Re: 8250 Marty Road (Klein) Extraterritorial CSM

Re: Klein Preliminary CSM Review

Re: Talarczyks' Preliminary Plat, Between Kubly and Airport Roads

SHEET
3 OF 9

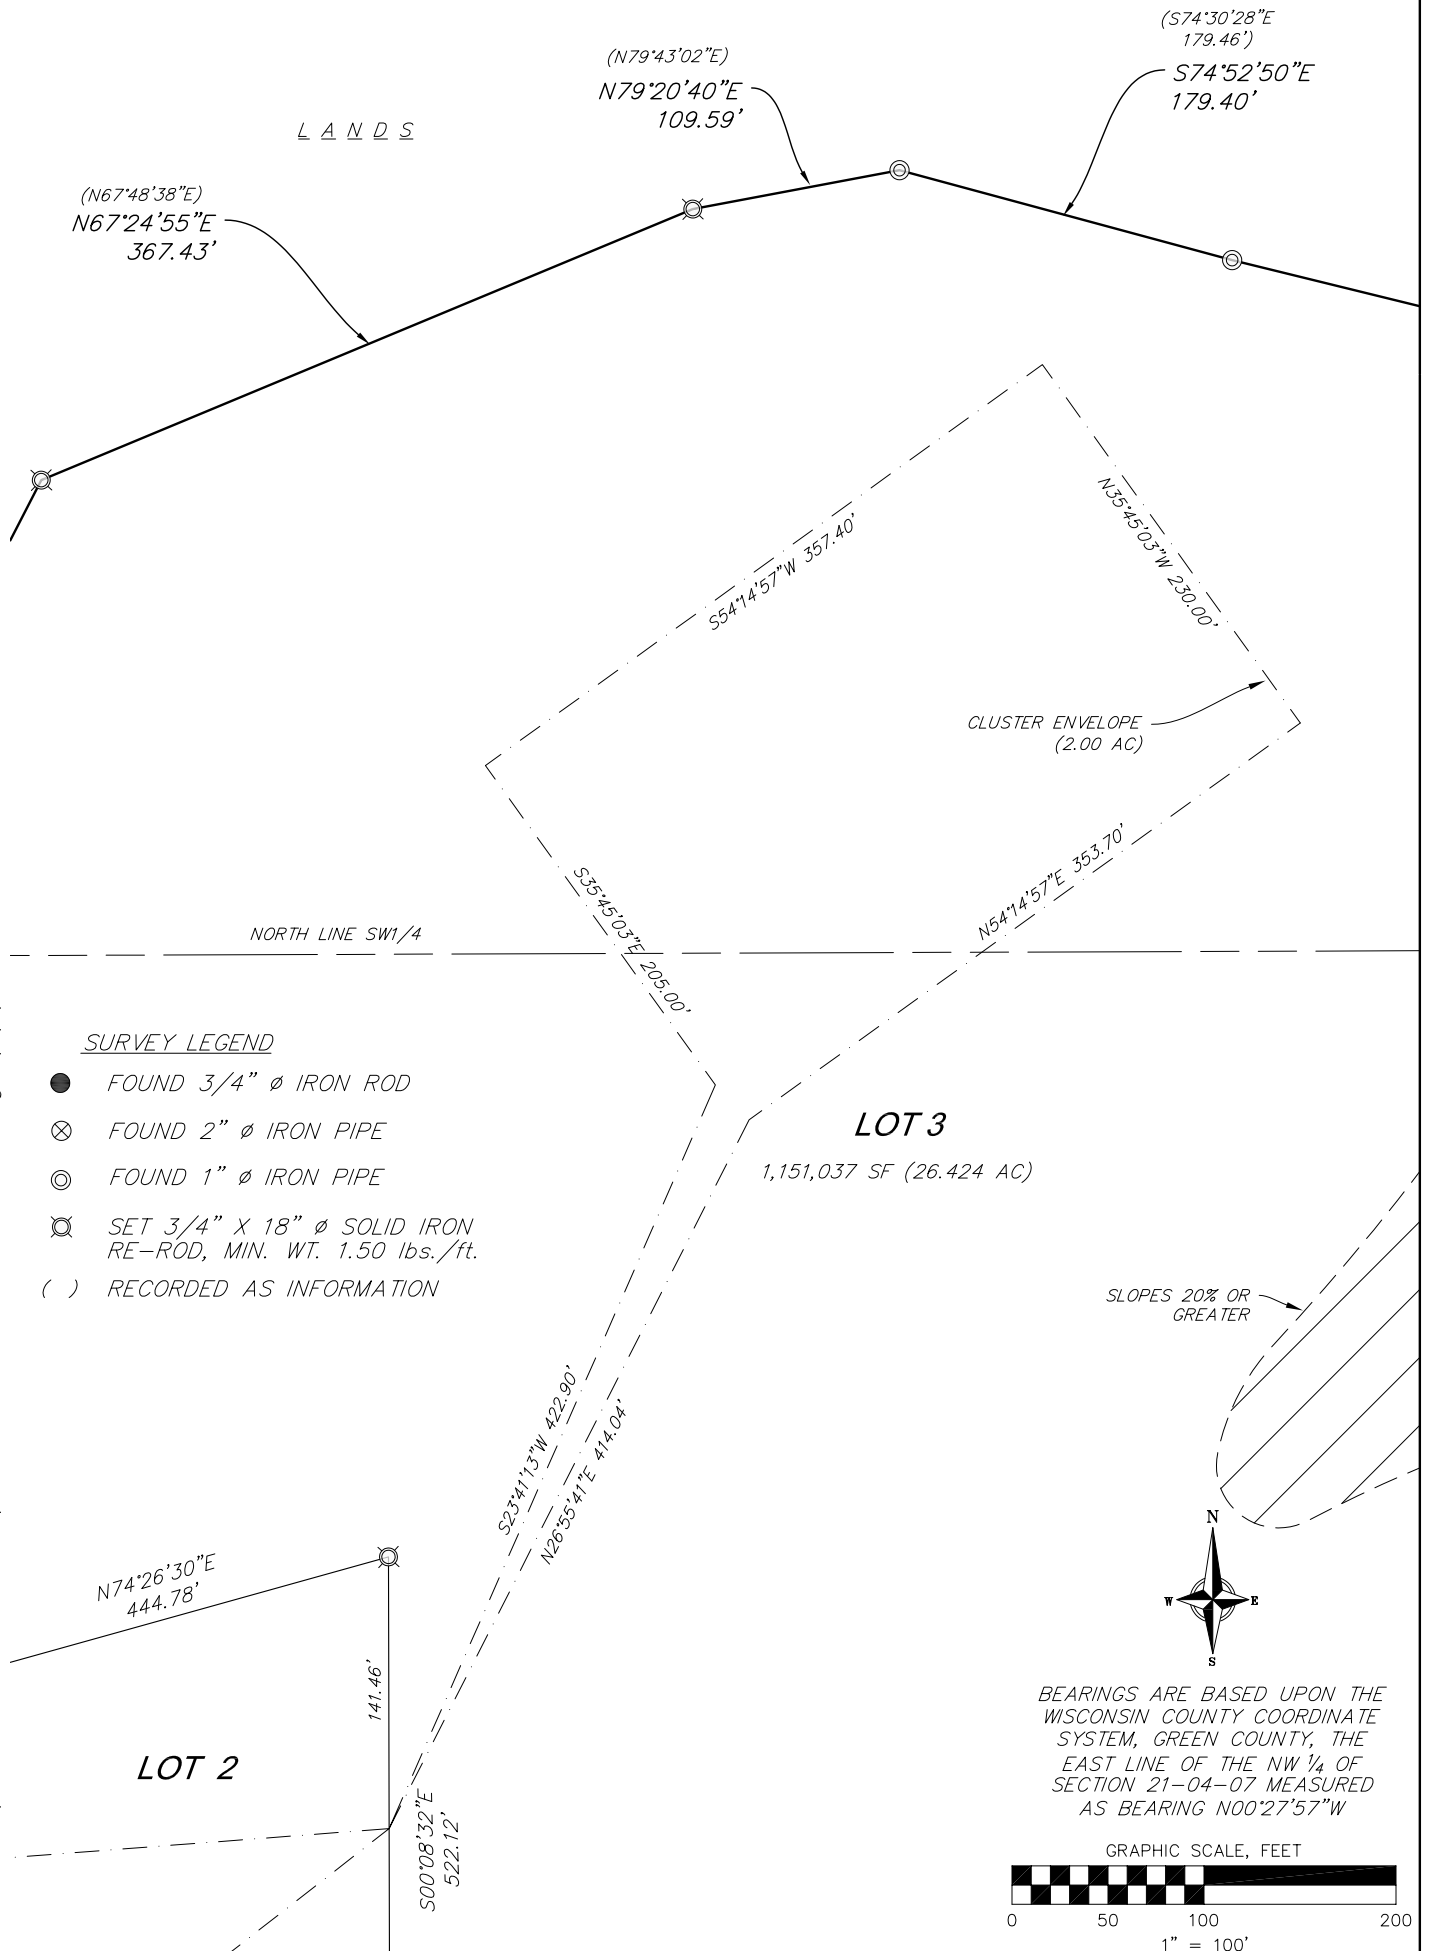
- b. Adjust the cluster envelope for CSM Lot 3 to have a western edge no closer than less than 80 feet from the eastern Marty Road right-of-way edge.
 - c. On Sheet 5, correct spelling of “pavement” and specify whose responsibility it will be to relocate the existing driveway, and when or via what triggering event.

The slope of the hillsides proposed for the proposed lots vary with some sections that exceed a 20% grade. These areas have been noted on the CSM and are outside of proposed the cluster envelopes. Access for Lot 3 will require construction of a long driveway across areas where the terrain is steep. Therefore, we recommend the Town require lot 3 to submit a site plan for the proposed building location and which including a driveway plan for review and approval by the Town prior to building permit issuance. A note to this effect should be included on page 3 of the CSM stating:

"Residential home construction on Lot 3 will require submittal of a site plan demonstrating compliance with the Town of New Glarus Driveway Ordinance (Chapter 36) and depicting the proposed home location within the cluster envelope."

TALARCZYKS' PRELIMINARY PLAT

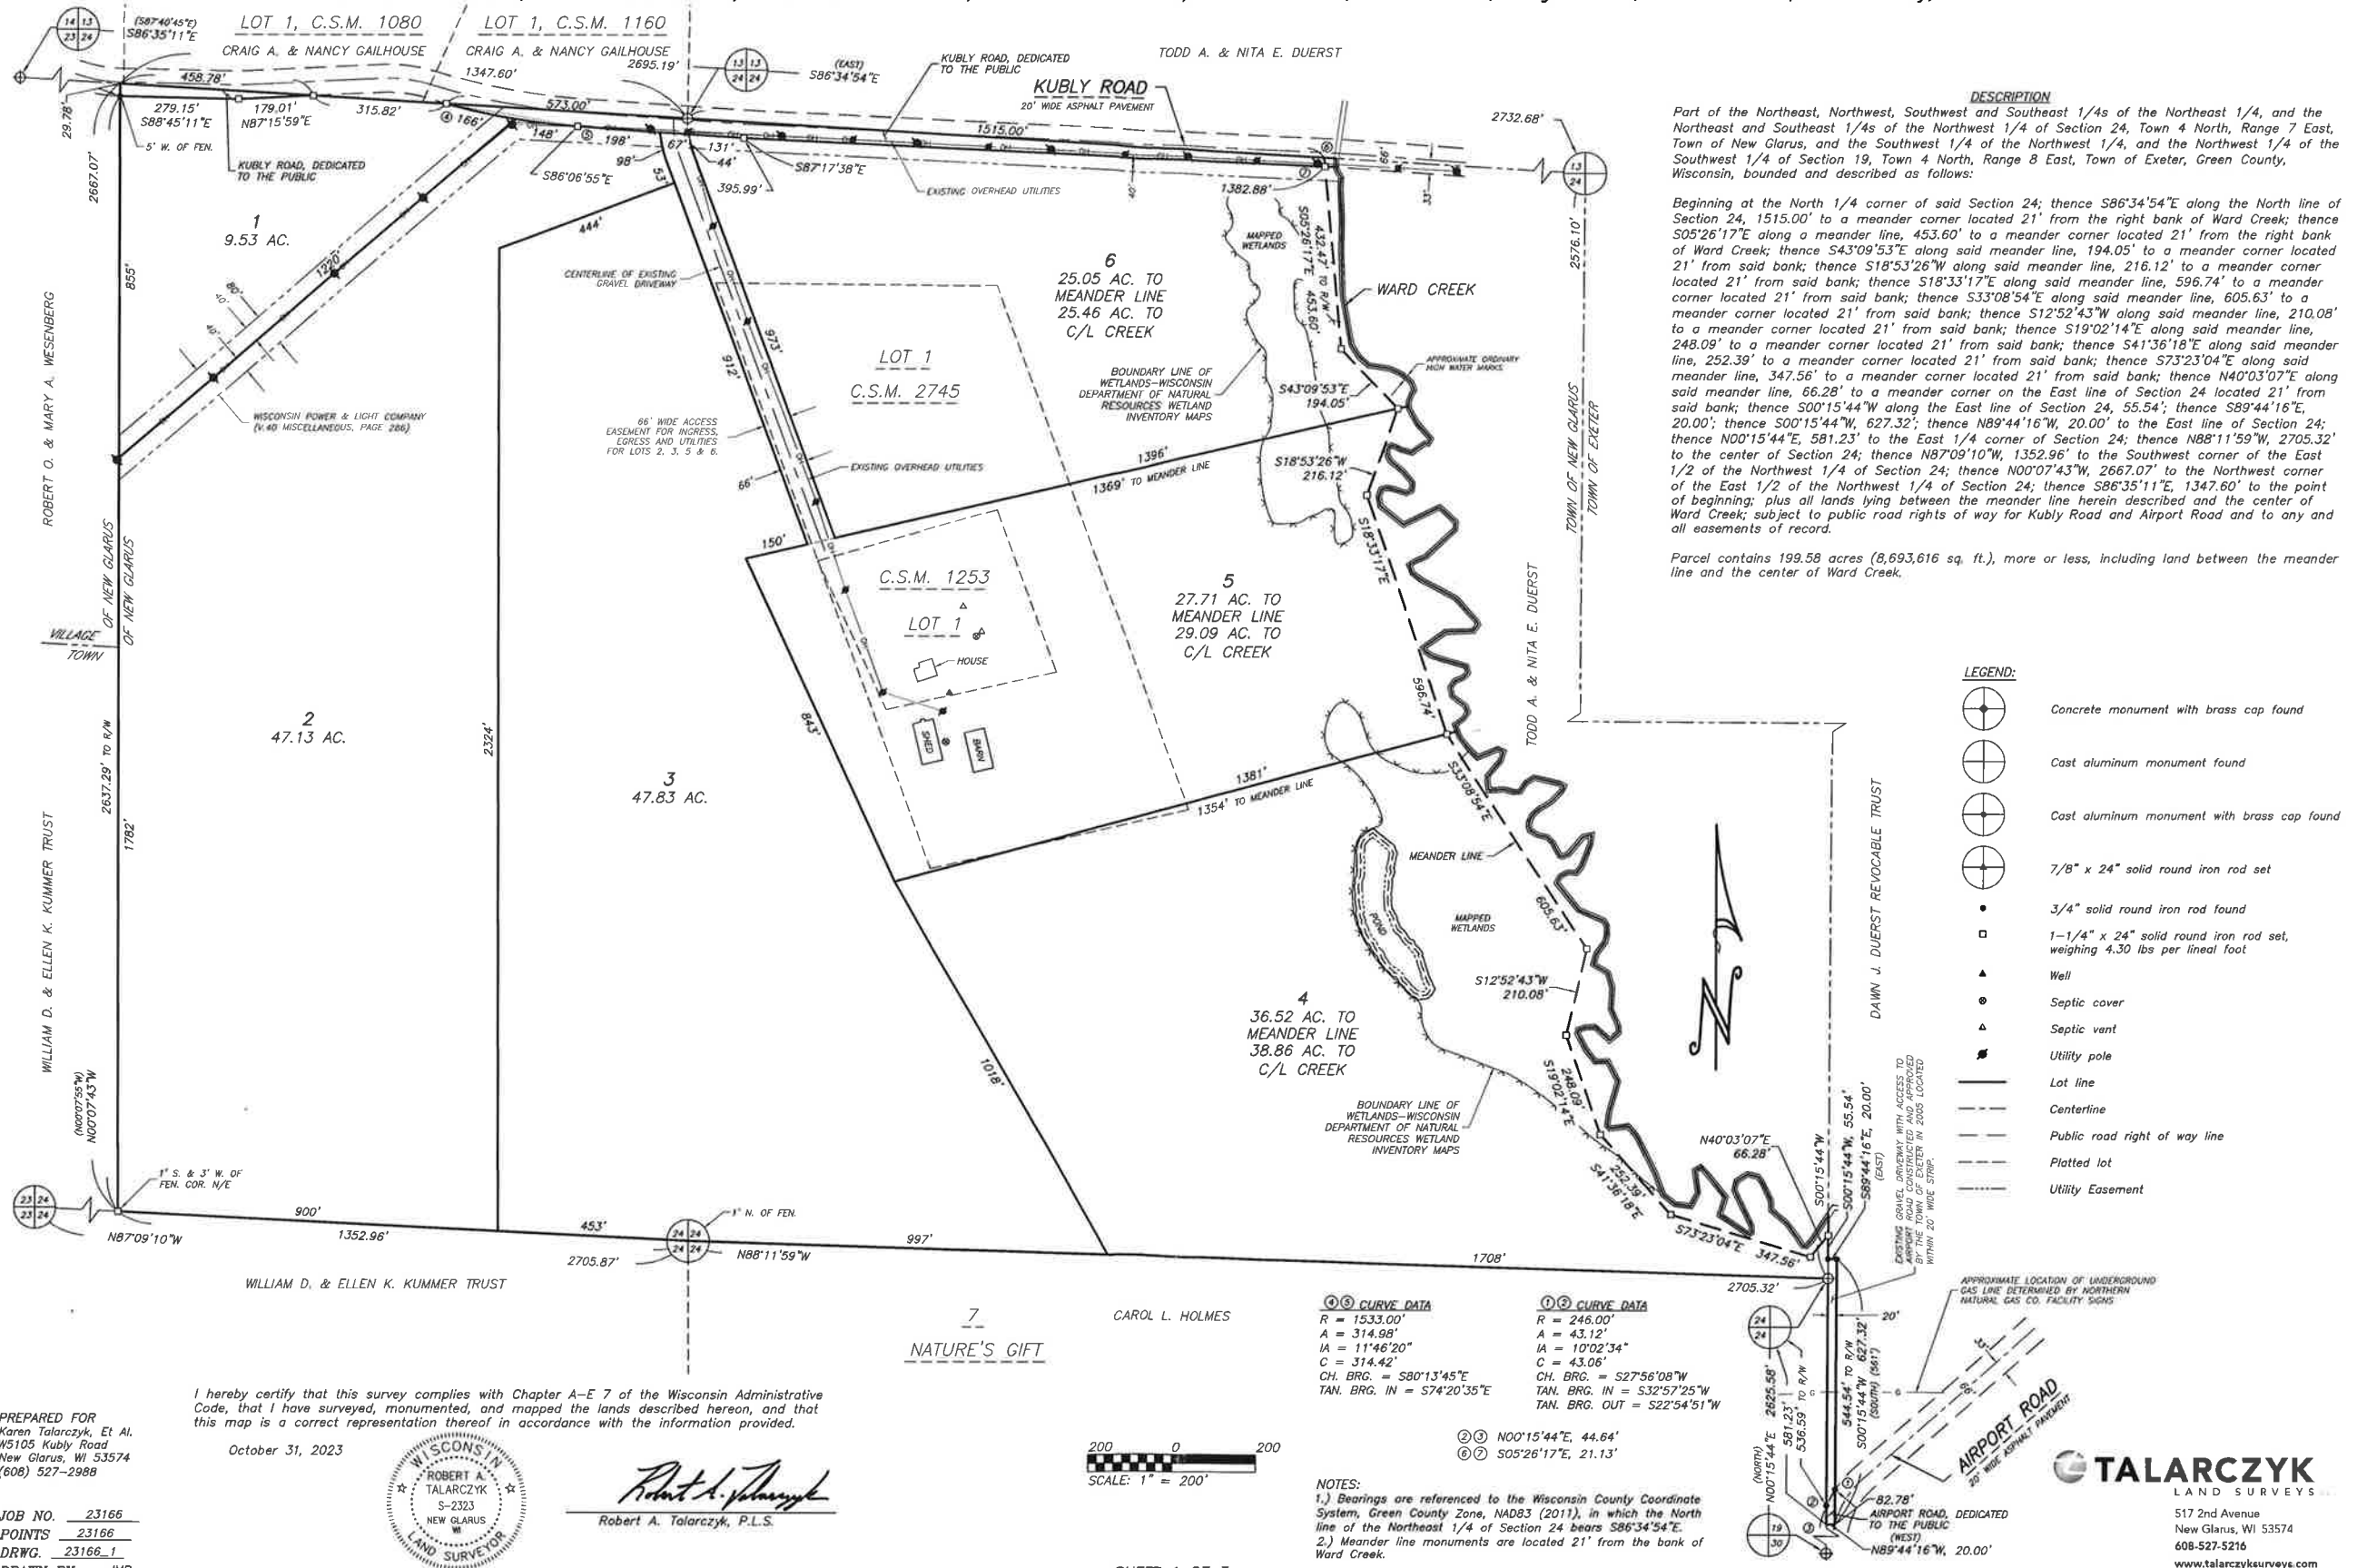
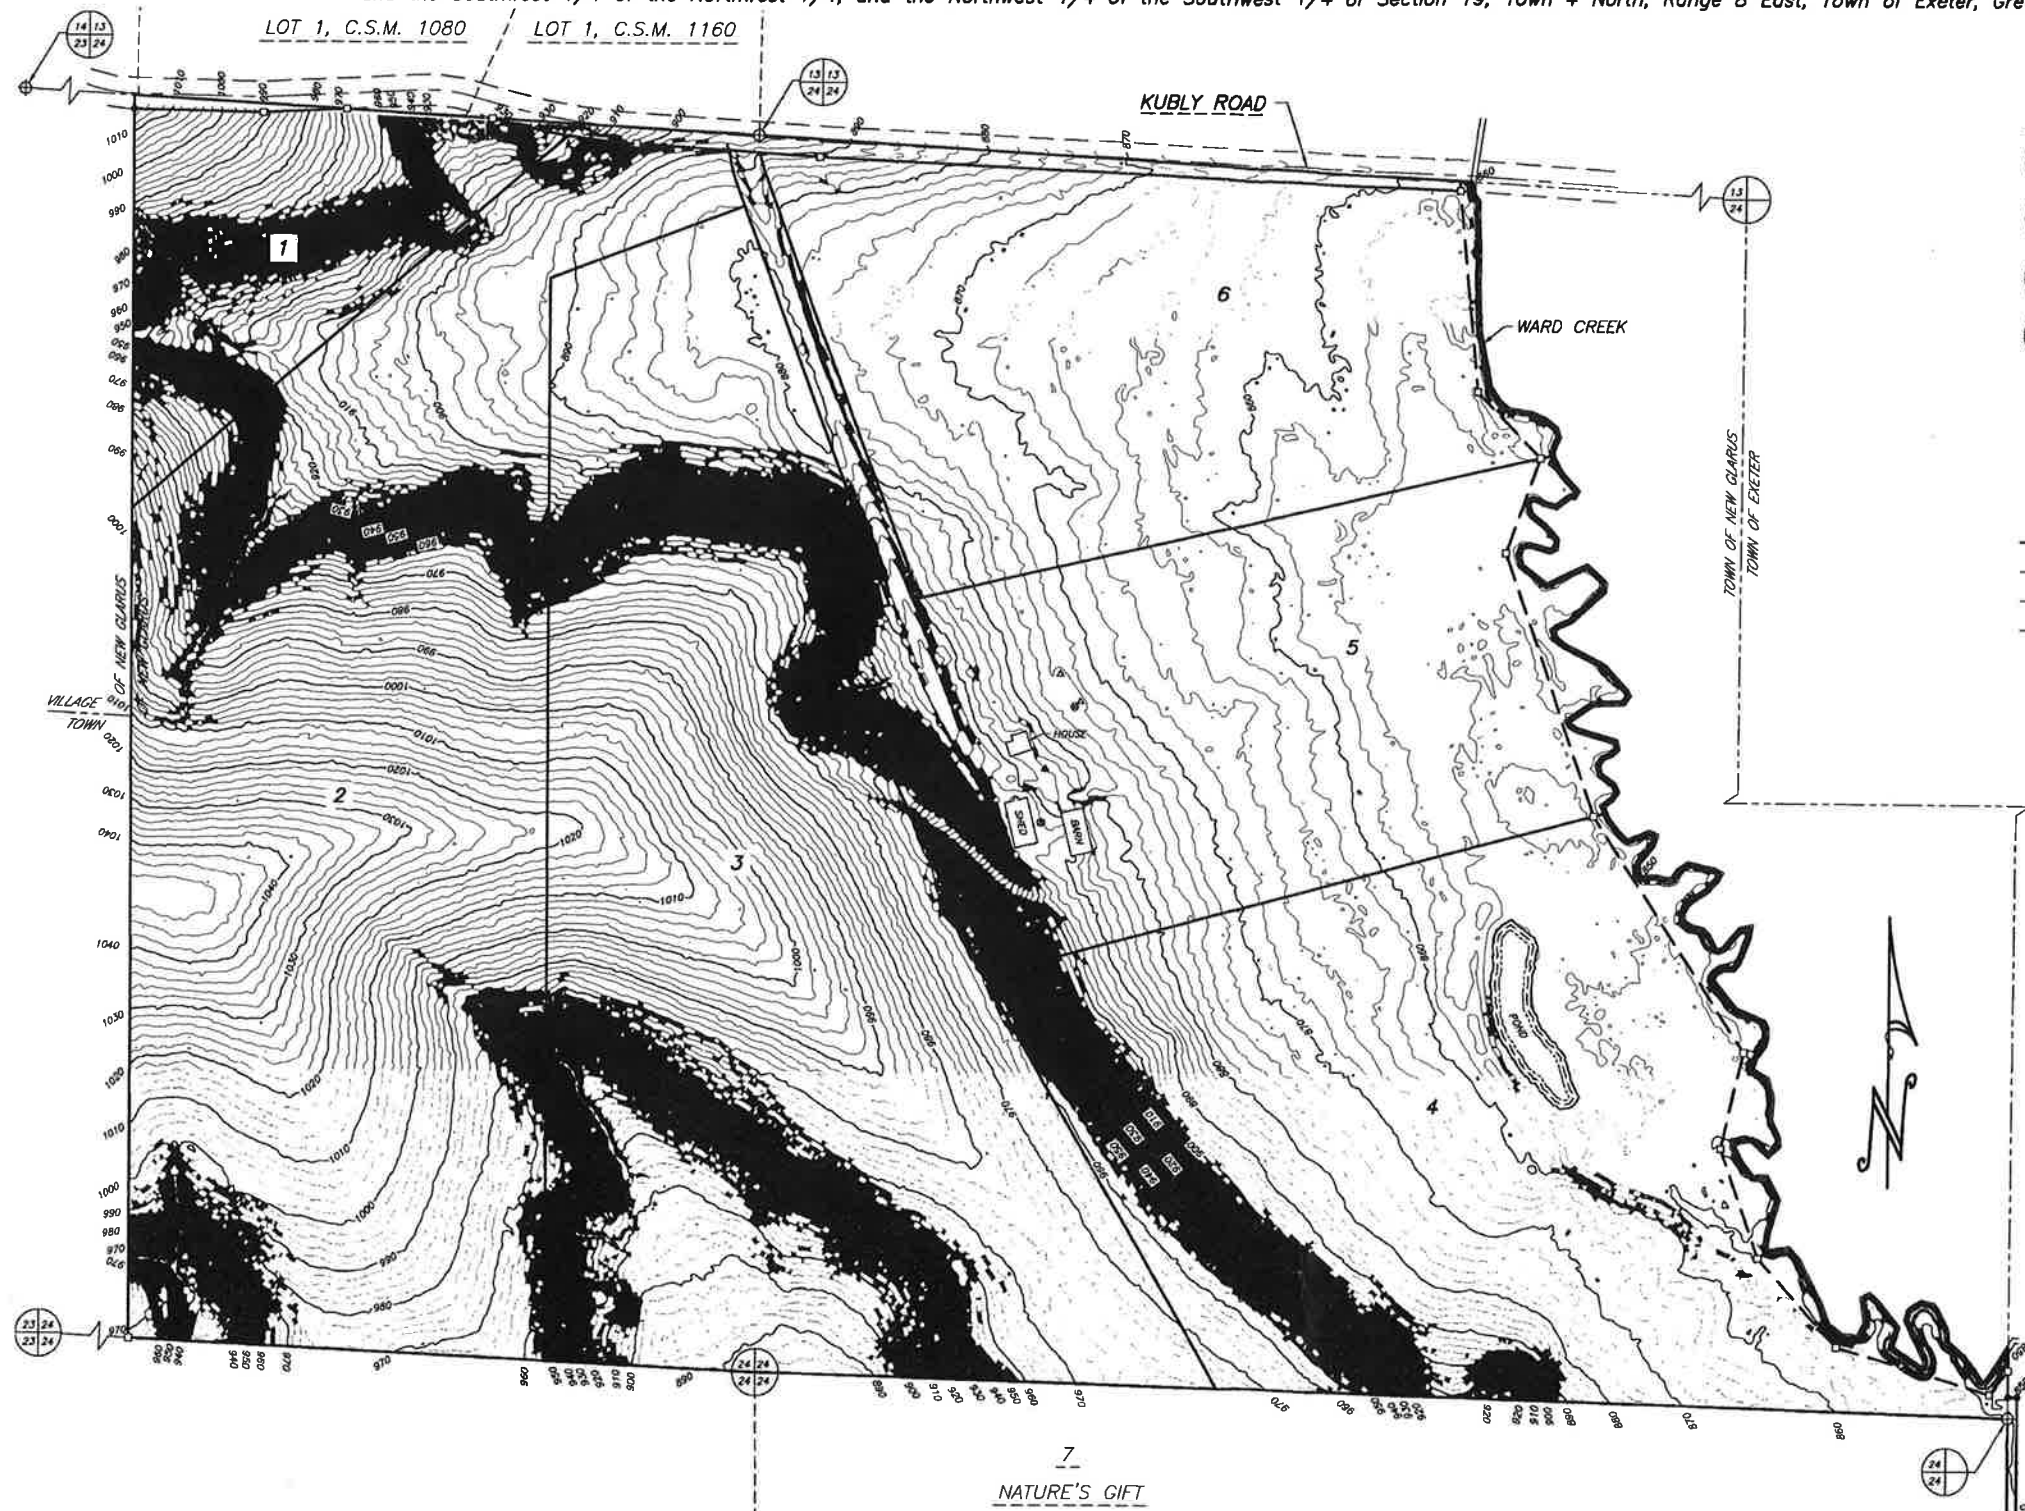
2. The final plat submitted for Village approval shall include, on or with the plat map:
 - a. Adjustments to lot boundaries such that all lots aside from Lot 4 have frontage on a public street.

- b. Floodplain limits and shoreland zoning boundaries.
 - c. The following note: "Through Section 823.08 of Wisconsin Statutes, the Wisconsin Legislature has adopted a right-to-farm law. This statute limits the remedies of owners of later established residential property to seek changes to preexisting agricultural practices in the vicinity of the residential property. Active agricultural operations are now taking place and may continue in the vicinity of this plat. These active agricultural operations may produce noises, odors, dust, machinery traffic, or other conditions during all hours of the day and night."

- d. Provisions for protection of mature woodlands and 20%+ slopes within the plat, which may include disturbance restrictions per Town ordinance or otherwise.

- e. Provisions to minimize visibility of future homes from public streets, which may include deep building setbacks from Kubly Roads and tree preservation within said setback area.
- f. Utility easement for the power lines that cross the northern part of the plat area.
- g. Features to meet plat submittal requirements of Section 265-19.
- h. A separate draft deed restriction preventing the separate transfer of parcel 2301401321000 in the Town of Exeter from proposed Lot 4 (both shall be and remain in common ownership).
